April 25, 2019

**SUBJECT: Response to PA DEP and East Rockhill Township Comments
Qualitative Geologic Survey Sampling Plan
Rock Hill Quarry, SMP No. 7974SM1
East Rockhill Township, Bucks County, PA
EARTHRES Project No. 061003.051**

Figure 1 – Geologic Features and Coring Location Plan

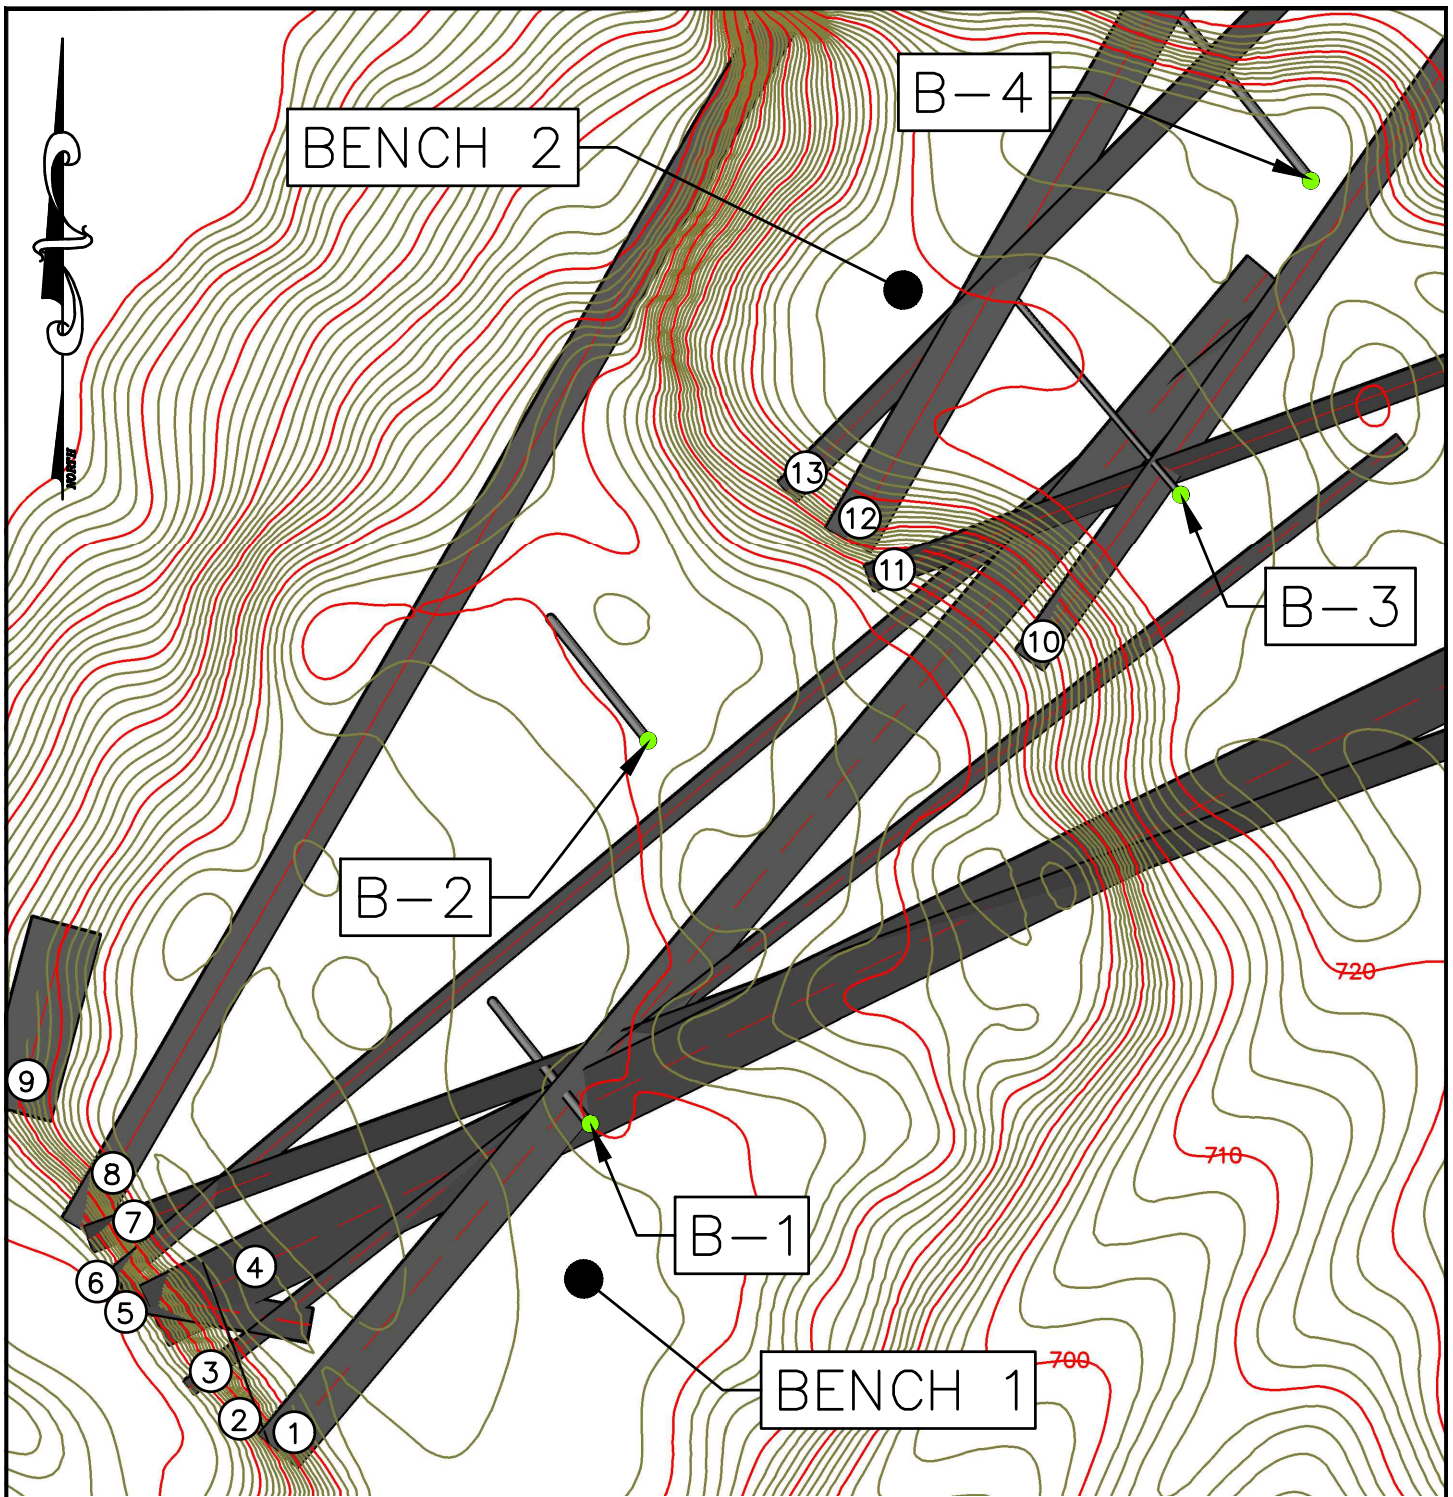
- 3) **Both the NSSGA Guide and the Aggregates Handbook encourage a proper mapping effort as part of the investigations described in these documents. The Department has notified Hanson during the December and February meetings and during other discussions that it expects the veins at the Rock Hill quarry to be mapped and described. To date, the Department has not received any information from Hanson regarding the mapping effort or its results. Results from a comprehensive mapping effort could effectively answer the Department's comments #1, #3 and #4 regarding the core drilling as well as East Rockhill Township's comment #4.**

4. **Rock Coring and Sampling Frequency:** While the amount of material in the "planned mining area" is not described in the Plan, the number and spacing of the rock cores shown on Figure 1B is insufficient. The cores are spaced approximately 75 to 250 feet apart, and many asbestos-containing mineral veins could exist between the cores and would therefore not be accounted for in the survey.

The proposed coring locations and mapped features are shown in map view on the attached Figure 1. The cores will be drilled on an approximately 30-degree angle from vertical with an azimuth of approximately N45W. The drilling direction is oriented perpendicular to geological strike and is dipping opposite of the found features in order to intercept as many potential features as practical. The core borings will be advanced to an elevation of approximately 585 feet above mean sea level (MSL), which is approximately equivalent to the current water level in the Quarry pit.

Core Borings 1 (B-1) and B-2 are proposed to be located on Bench 1. The B-1 location was chosen to intercept the Veins 1, 3, 4, and 7. Coring B-2 is proposed in an area where face-mapped features are not projected to be present, thus providing additional geological coverage.

Core Borings B-3 and B-4 are proposed to be located on Bench 2. The B-3 location was chosen to intercept the Veins 1, 6, 10 and 11. B-4 is proposed to intercept Veins 12 and 13 and provide additional geological coverage in an area where face-mapped features are not projected to be present.

Please see our detailed response to the Department's Comment #3. The drilling locations were adjusted as described based upon the found geological features. If the results indicate the presence of naturally occurring asbestos-containing mineral veins, additional sampling may be proposed.
